**PD Modification Application: MM 22-0686 – REMAND**

Zoning Hearing Master Date: March 20, 2023

## AGENCY REVIEW COMMENT SHEET

### 2.5 Proposed Site Plan (partial provided below for size and orientation purposes. See Section 8.2 for full site plan)

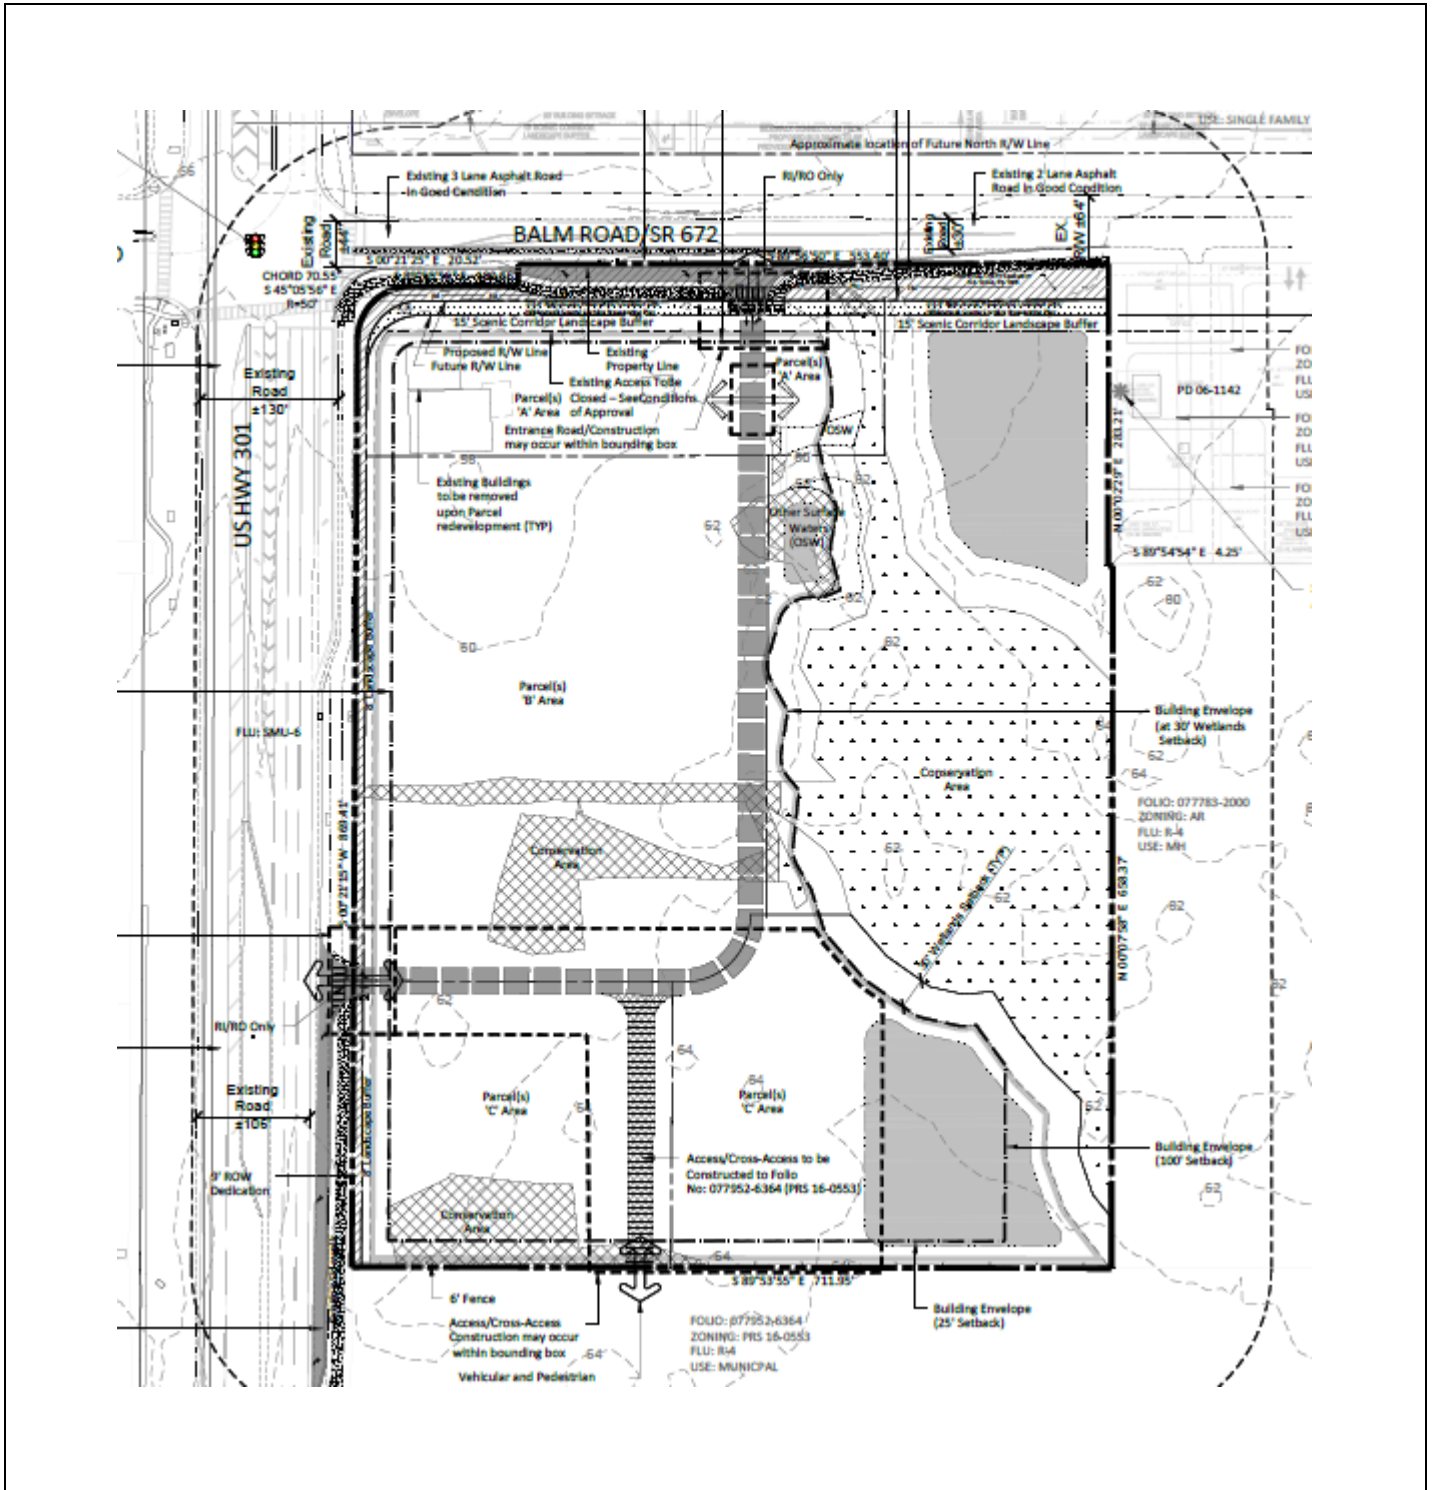
1. Delete the bounding box and internal access arrows indicating access to/from Parcel A. Staff notes that these arrows are confusing, as Parcel B does not have similar access arrows. More importantly, staff has previously raised concerns that given the intensity of development, the minimum throat depth requirements may necessitate Parcel A to take its access through Parcel B (as noted in staff’s proposed conditions). As such, these arrows may conflict with that condition and are otherwise inconsistent as noted above; and,
2. Modify the symbology for the required vehicular cross access to the southern project boundary, such that it matches the symbology for the other internal access drive and delete the “Conceptual Future Access” shading and notations within the legend.

The applicant has requested two PD Variations to LDC Section 6.06.06.

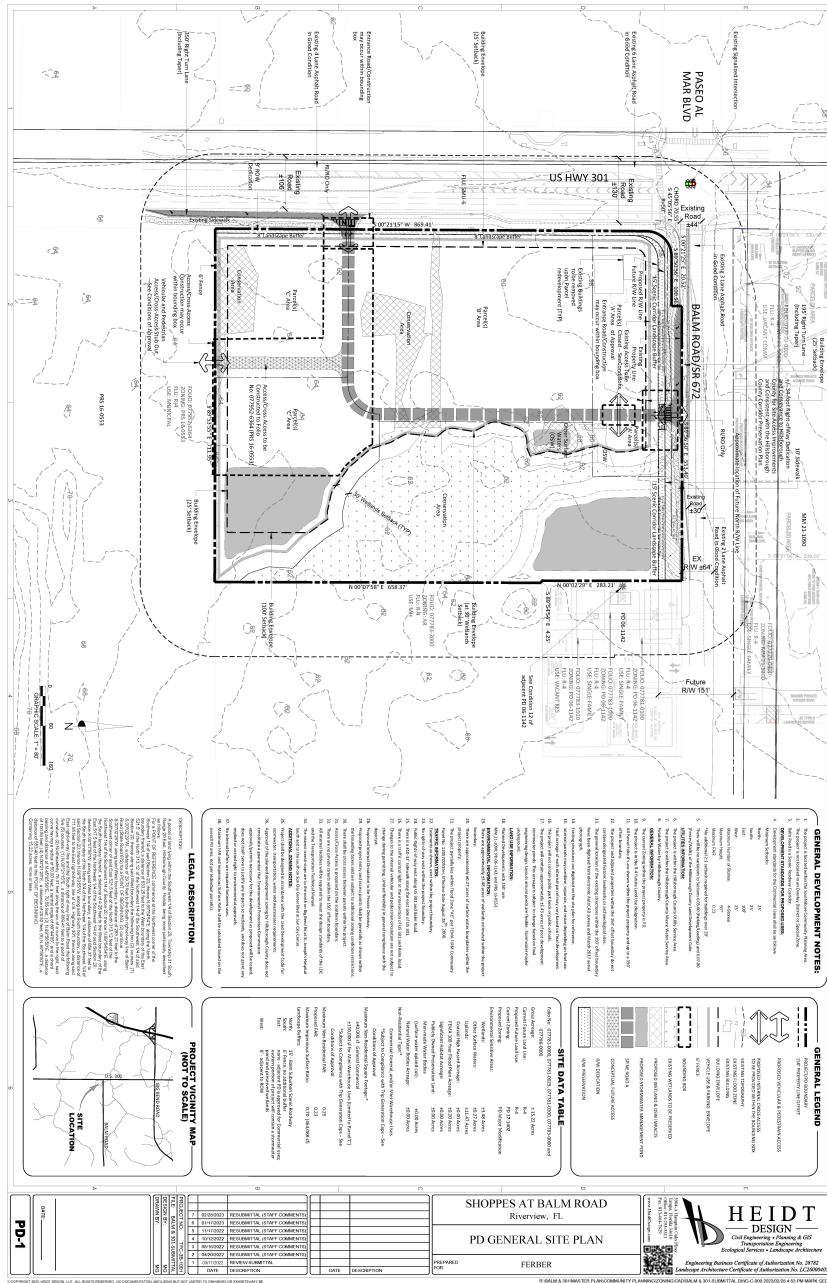
- (1) A 20-foot wide buffer with Type B screening is required along the eastern property line where abutting the AR zoned property and where abutting the PD zoned property given that it is currently developed with residential. The minimum 20-foot wide buffer can be provided given the proposed location of development. Existing vegetation which is present along the eastern boundary is proposed to be utilized for screening purposes (as shown in the applicant's submitted photographs). Additionally, development in proximity to the eastern properties will be limited due to intervening wetlands and proposed stormwater ponds.

- (2) A 20-foot wide buffer with Type B screening is required along the southern property line. No required buffer is proposed; however a building setback of 25 feet is proposed. Screening will consist of a 6-foot high fence (Type A screening) and existing vegetation. The area adjacent to the subject PD is a 15+ acre of property used for open space and stormwater retention. Residential development is located over 600 feet from the PD's southern boundary.

FIGURE 2. PROPOSED TYPICAL SECTION

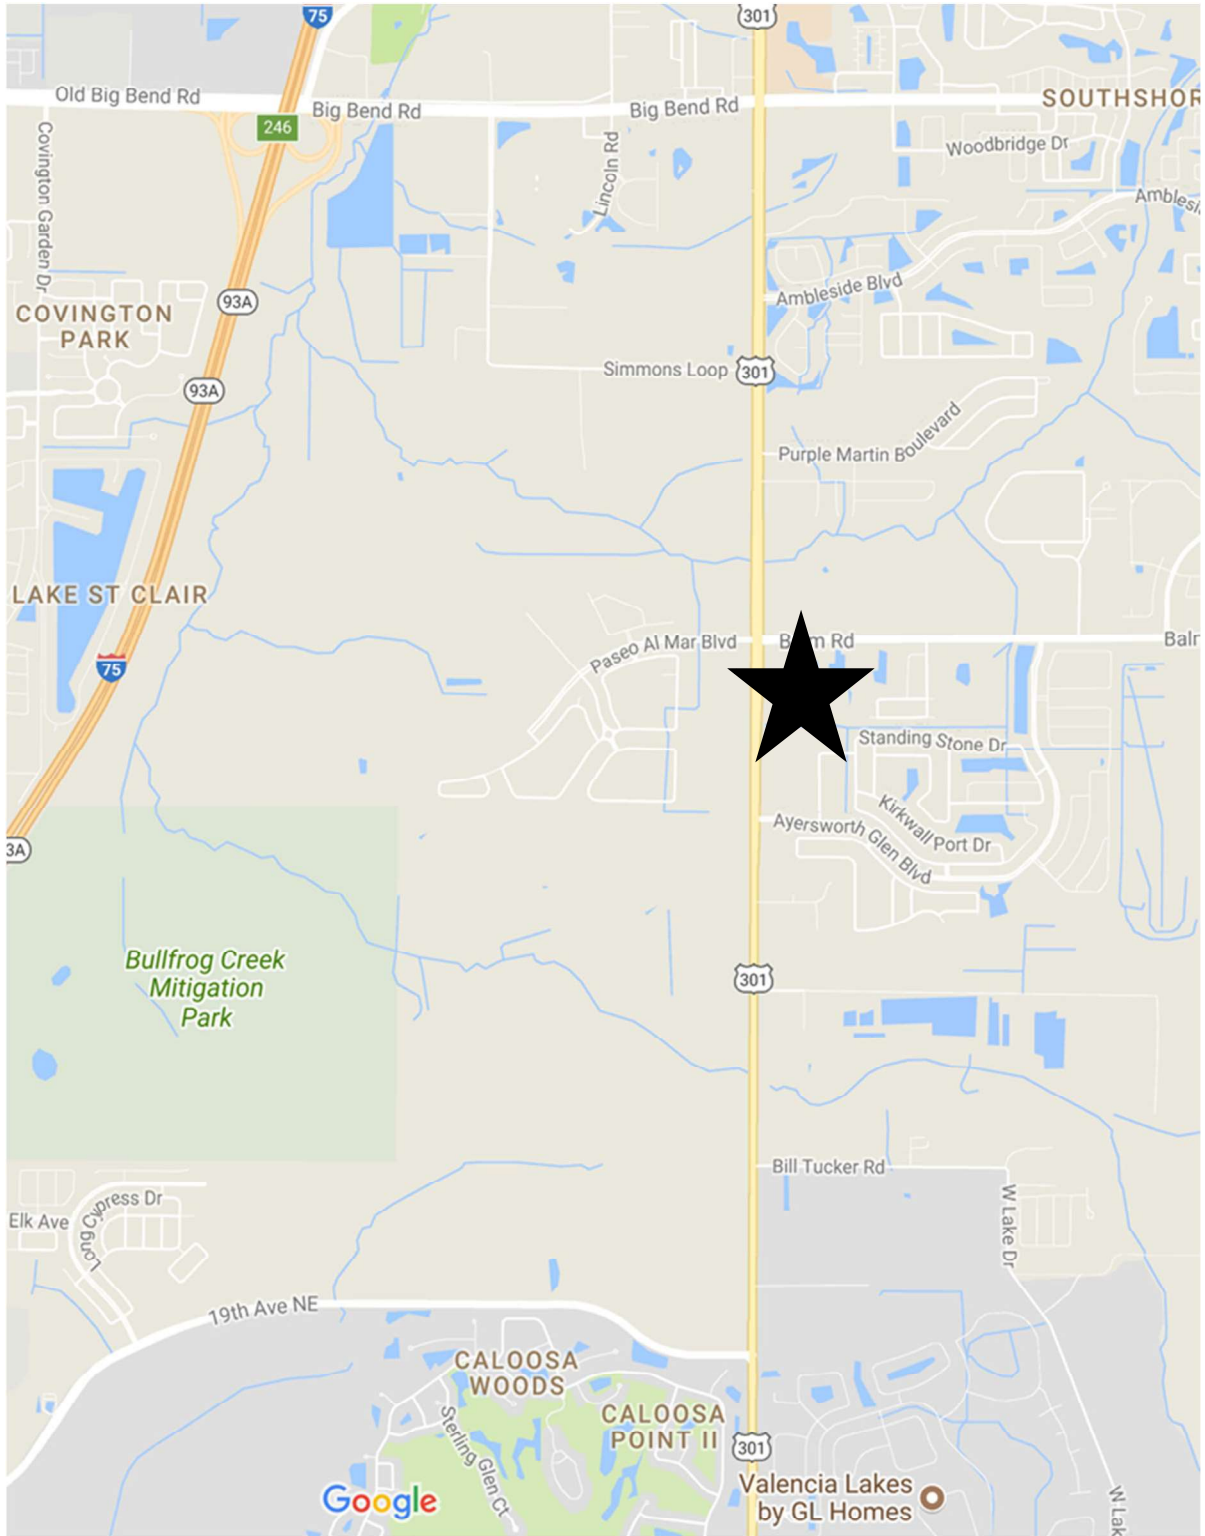
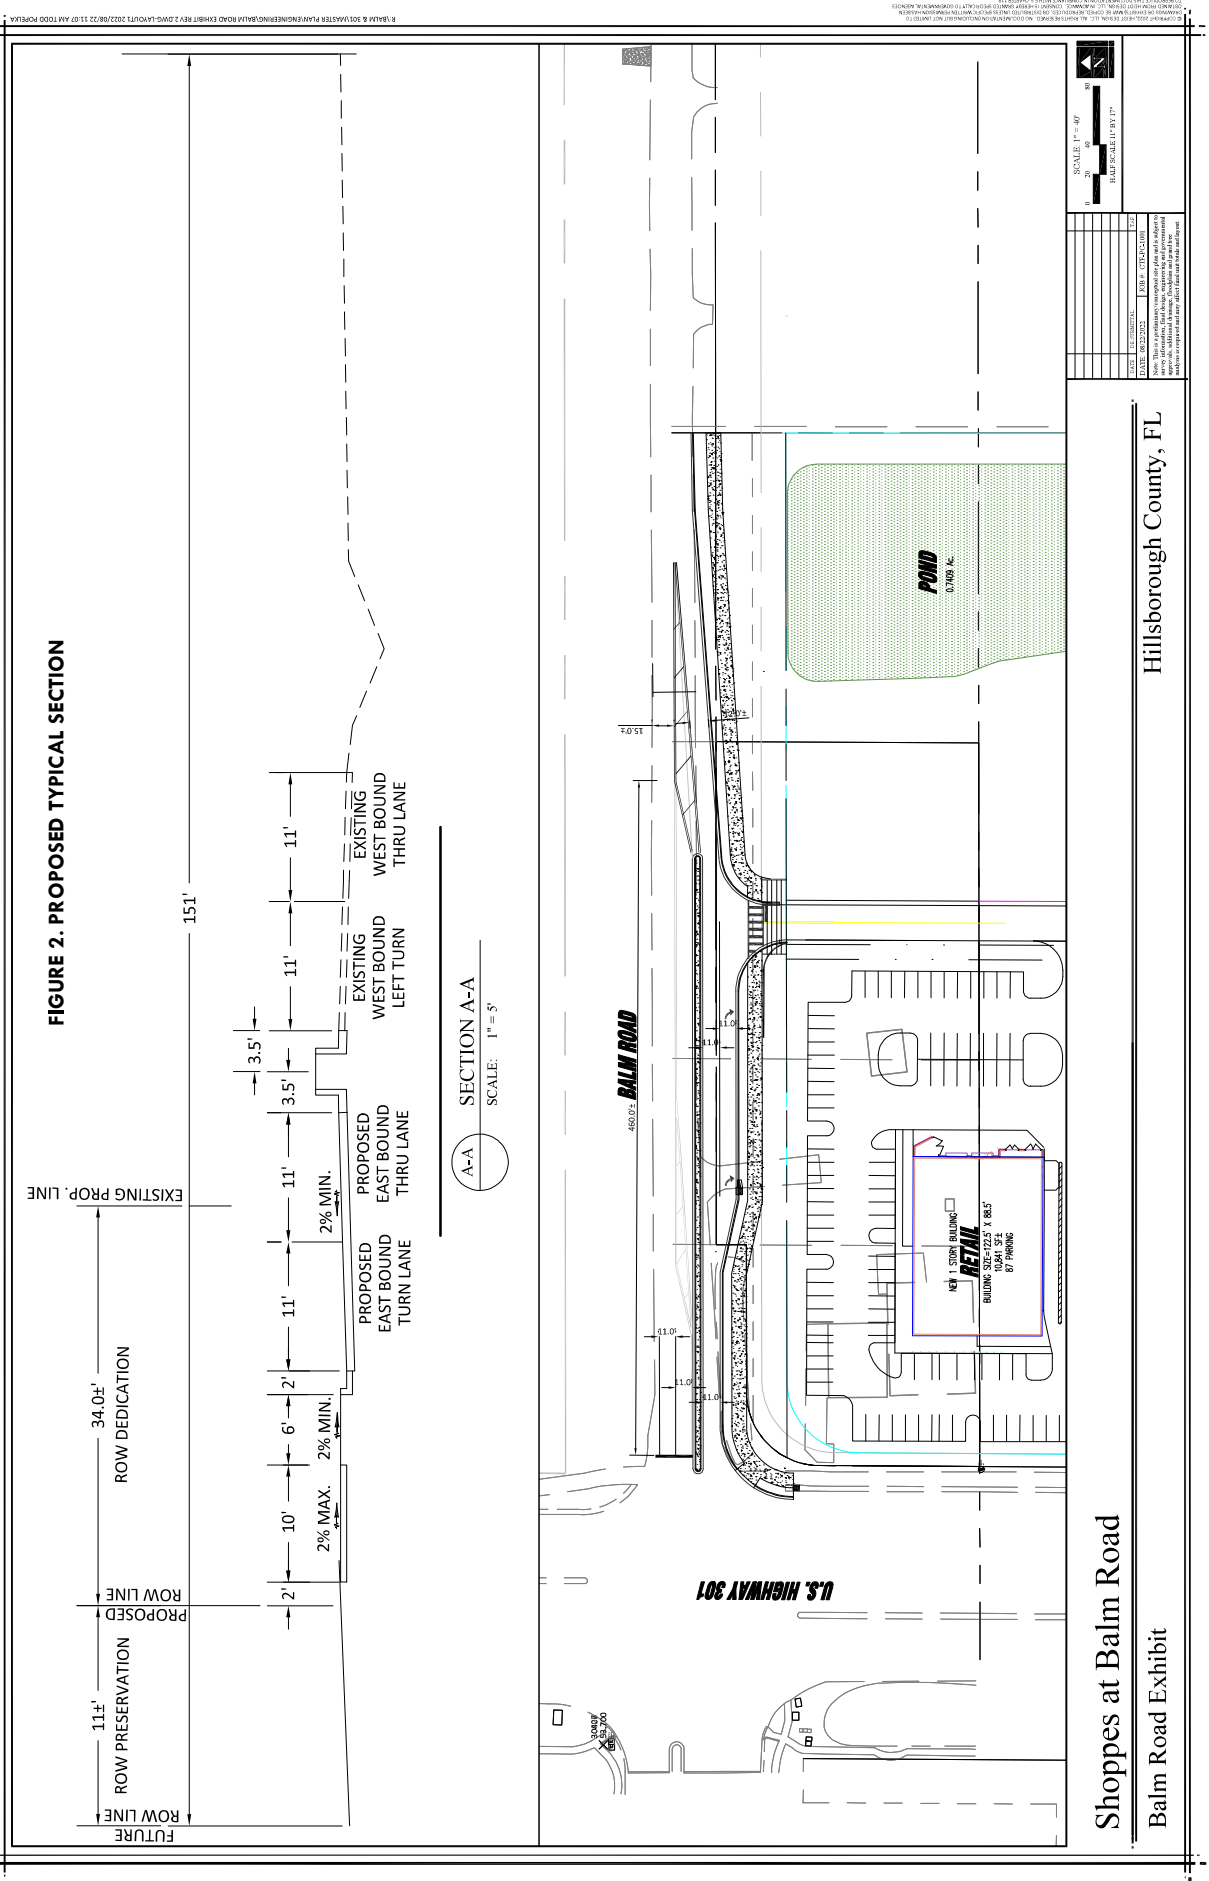
1. Per the design exception approved for PD 20-1270, a 4-foot-wide traffic separator will be provided to prevent westbound and northbound left turns at the project driveway on Balm Road. The traffic separator will be designed in accordance with FDOT Standard plans #520-020 (4'-wide option). Additionally, in accordance with FDOT Standard Plans 711-001, 18" has been provided between the edge of traffic separator and the lane stripe.

2. The request is to provide 11-foot travel and turn lanes instead of the 12-foot lanes. According to the Florida Green Book, on a suburban roadway where the speed limit is between 40 and 45 mph, 11-foot lanes may be used. The posted speed limit on Balm Road is 35 mph.

3. Provide an 11-foot wide, 195-foot-long eastbound right turn lane at the project driveway.
4. The westbound left turn lane at the intersection of US 301 and Balm Road will be extended to approximately 400 feet, including a 50-foot taper.

- 5. An F type curb and 10-foot multi-use path will be provided only on the south side of Balm Road from US 301 east to the eastern property line. The improvements described in this request will require approximately 34 feet of ROW dedication and an additional 11 feet of ROW preservation for ultimate geometry of the intersection. The F type curb and 10-foot multi-use path along the southside of Balm Road are consistent with the CIP project (69638041) preliminary design.
- 6. No modification to the northern edge of pavement, as all improvements will be made on the southside of Balm Road. Again, an approved design exception for PD 20-1270 has improvements on the northside of Balm Road.
